Subject NA2, Nairn, Transport Assessment (Response to Transport Scotland)

Planning application no. 17/05667/FUL

Table 1: Transport Scotland Comments and Arup Response

Appendix C – *LinSig* Model Outputs (full)

Project:	
Title:	
Location:	
File name:	A96-Lochloy Road-View Road (sensitivity) - TS Update - Standard Error of the Mean.lsg3x
Author:	
Company:	
Address:	
Notes:	Results based on a 12 second pedestrian intergreen

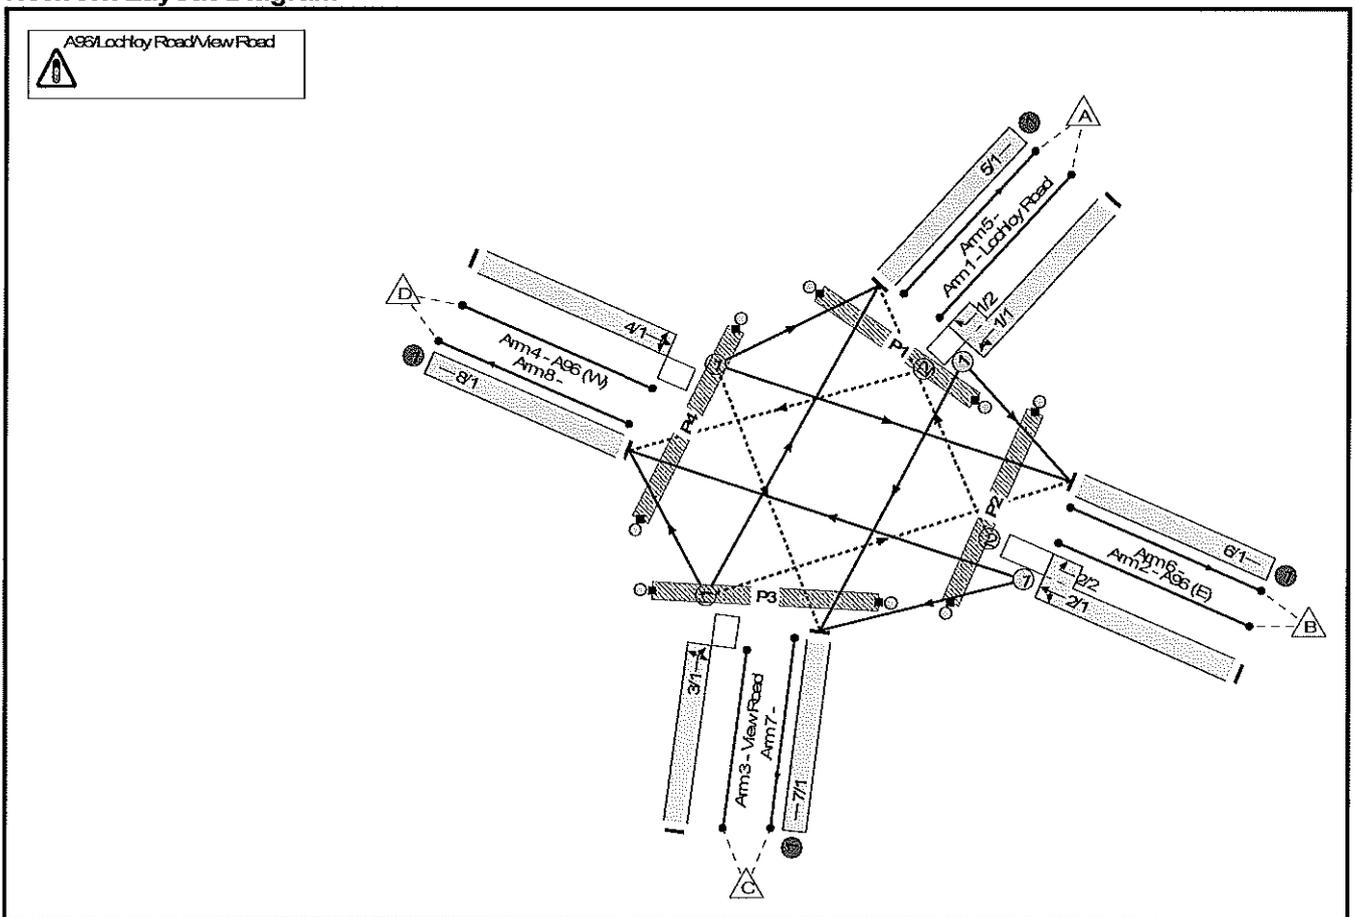
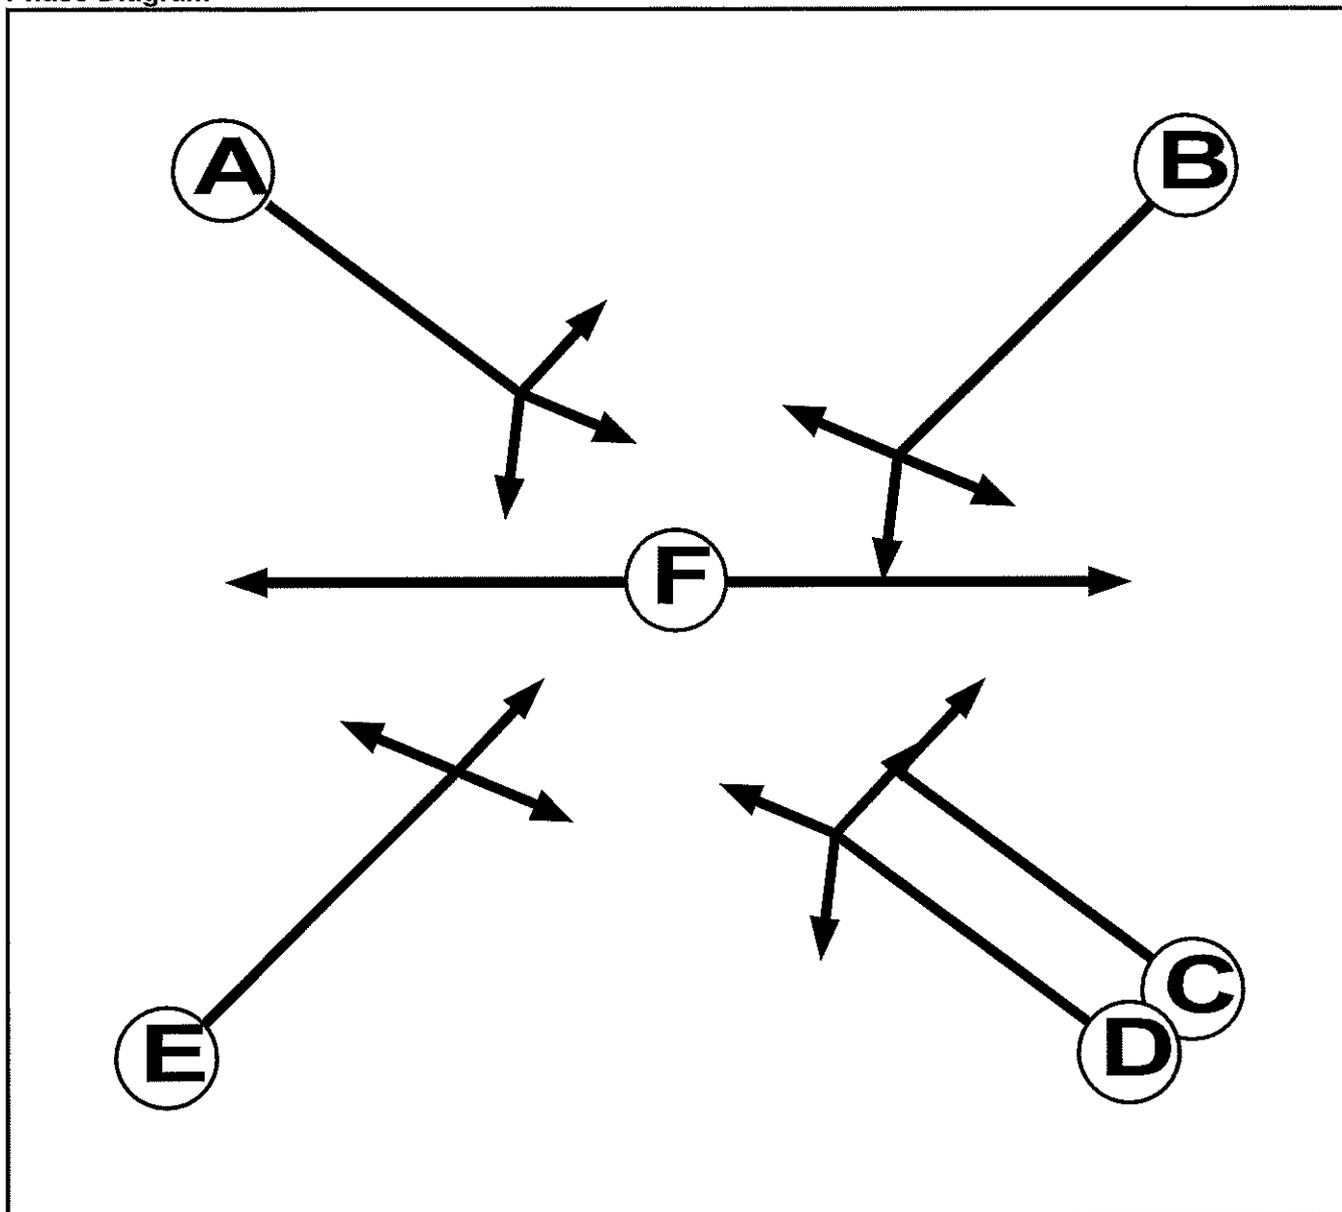
7 (d)	<p>In terms of which model, it is considered appropriate to use the model with Phase C coded as an Indicative Arrow (IA) phase. However, it is noted that when coding the Lane 2/2 details, the IA phase C has not been associated with the main traffic phase D resulting in Stage 2 indicating no minimum green time on the stage diagram. This should be amended when re-running the model.</p>	<p>The coding amendment suggested by TS has been incorporated into the revised <i>LinSig</i> model. Refer also to response no. 7 (c).</p>
7 (e)	<p>The reported results, which will change as a consequence of the above, currently indicate queues in excess of 100m on the A96 west approach in both the 'Base 2019' and 'Total 2019' traffic flow scenarios.....</p>	<p>The results and commentary of the amended <i>LinSig</i> modelling exercise are presented in response no. 7 (c) and Appendix B.</p>
7 (f)	<p>..... We would therefore seek clarification what steps have been taken to ensure that the predicted queuing in the base model is representative of actual conditions on the ground.</p>	<p>Refer to the <i>LinSig</i> results from the re-run model, along with associated commentary, as presented in response no. 7 (c) and Appendix B.</p>

Ref	TS Comment (summarised)	Arup Response
		<p>undertaken based upon applying a 12 second intergreen to the pedestrian stage. This value has been derived by calculating the 'standard error of the mean'. Taking such an approach reflects the level of variance from a defined sample size, in this case, the full range of potential intergreen times from a minimum of 5 seconds through to a maximum of 17 seconds (as confirmed by TS).</p> <p>Calculating the 'standard error of the mean' results in a value of 1.08 seconds. Applying this to the average intergreen time (i.e. 11 seconds) therefore assumes a value of 12 seconds which reflects an intergreen from the upper range of possible times. This is considered a more realistic interpretation of the likely pedestrian intergreen times.</p> <p>Based upon the above, and the results presented in Appendix B, it is considered that the A96(T)/Lochloy Road junction will continue to operate under capacity following the addition of trips associated with the NA2 development proposals.</p>

The data presented in this Appendix includes a summary the *LinSig* modelling results from the revised model which now incorporates the modelling parameters suggested by TS. Refer to response no. 7 (c) for further details of this test. Refer also to Appendix C for the full set of *LinSig* model outputs.

Figure 1: Stage sequencing and double cycle

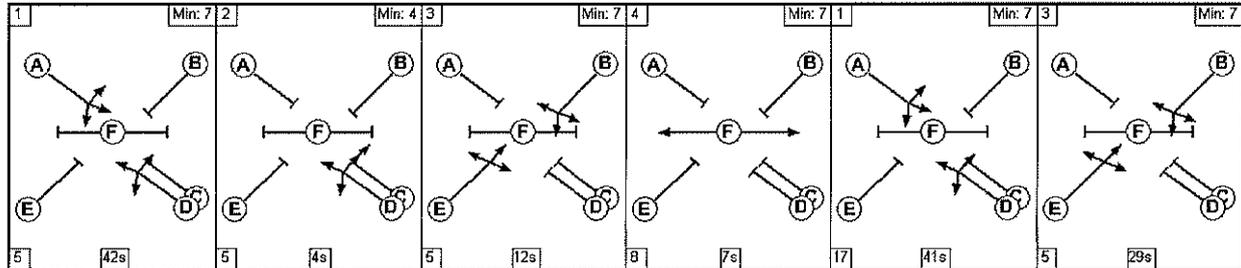
In their emails of 15/03/18 and 19/03/18, TS requested clarification on the stage sequencing and timings being assessed as part of the *LinSig* model for the A96(T)/Lochloy Road signalised junction. A number of sensitivity tests were subsequently undertaken, with the results from this exercise presented in a briefing note which was issued to TS on 21/03/18 (file reference: Transport Scotland Response 21-03-2018, NA2 Transport Assessment, Nairn, pdf).

The revised staging is illustrated in **Figure 1**.

Table 1 summarises the junction capacity results as outlined in the original TA. **Table 2** provides the same, but based upon the revised coding parameters in accordance with the latest TS request.
